ENGIE Electrabel

Subject: Electrabel's answer to the Public consultation on the methodology, the basis data and scenarios used for the study regarding the adequacy and flexibility needs of the Belgian power system for the period 2022-2032

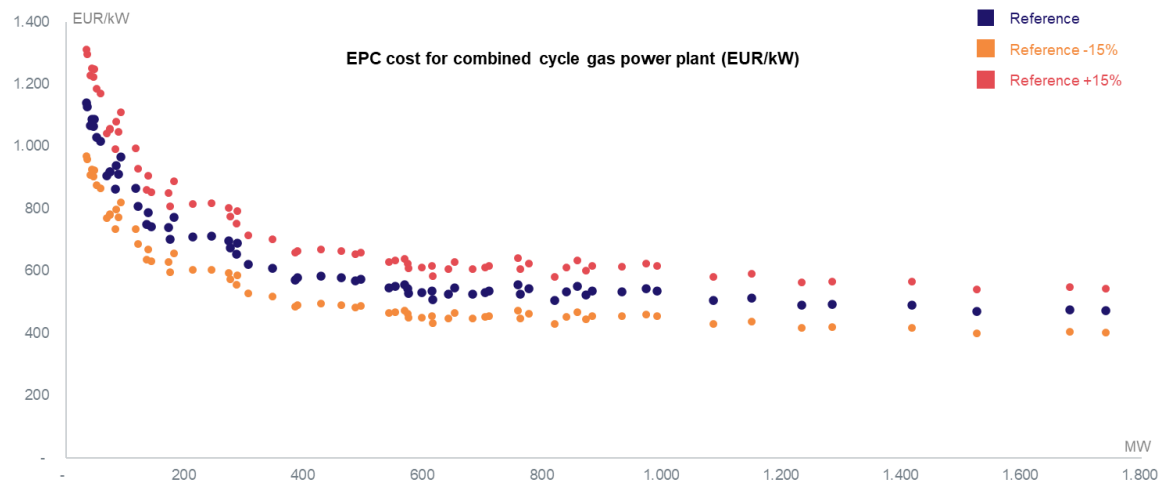
- **Shedding capacity:** Electrabel considers that applying a yearly increase of 5% for the coming years is too ambitious for the base-case scenario. While Electrabel is convinced about the role that Demand Side Response will play in the market in the coming years, we estimate that the strong increase observed in the last few years (cf. E-cube study) may not necessarily continue to materialize in the following decade – pending the full roll-out of the smart meters - as the additional DSM potential for certain types of grid users will be limited. In addition, Electrabel would like to remind that the methodology applied by E-Cube cannot ensure that the identified potential corresponds to market response only (e.g. at 150 €/MWh or more blocks could also be linked to super peakers like turbo jets or possibly OCGTs under some circumstances). In addition, the volume expected in terms of market response are highly different from ENTSO-E assumptions in their Mid-Term Adequacy Forecasts.

Given its experience in the CWE market, Electrabel doubts that this potential would become effective, without additional support, at the 2025-30 horizon. In comparison, in France where a capacity market is in place, Electrabel observes that “only” 3¹ GW of DSR² have been certified, in a market where the load is much more thermo-sensitive.

- **Shifting capacity:** Electrabel considers that the figures presented are also very ambitious and would like more insight about the evolution proposed in the framework of this consultation.

Flexibility Characteristics

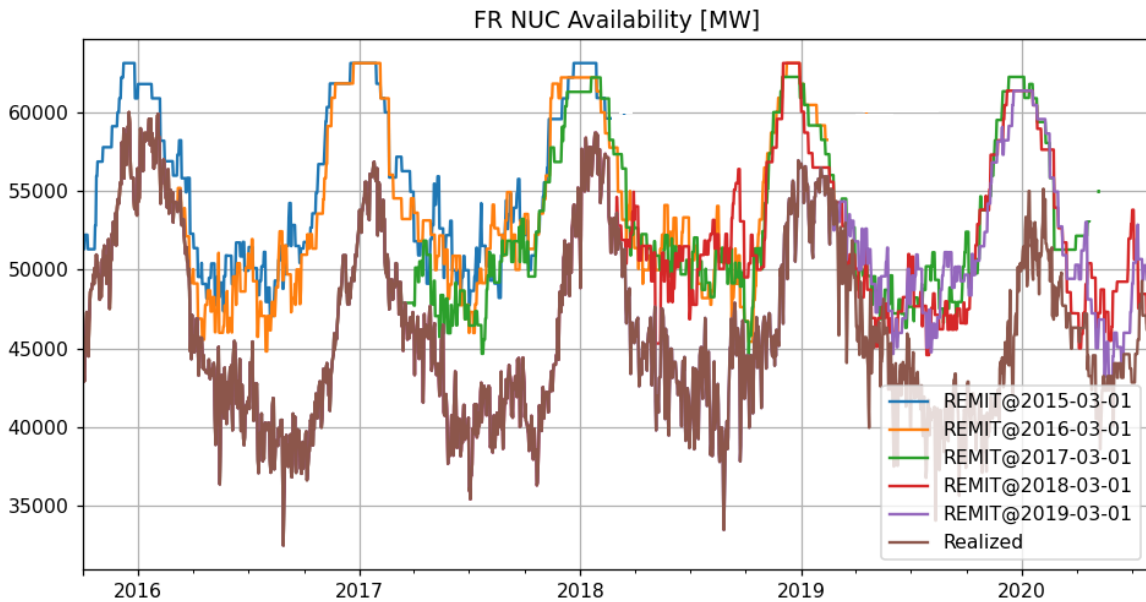
- Regarding “Minimum Down Time” for new and recent CCTG’s, for “Hot Start up time”, of respectively 0.5 hour and 1 hour seems very optimistic and should reasonably be set at 1 hour and 1.5 hour.
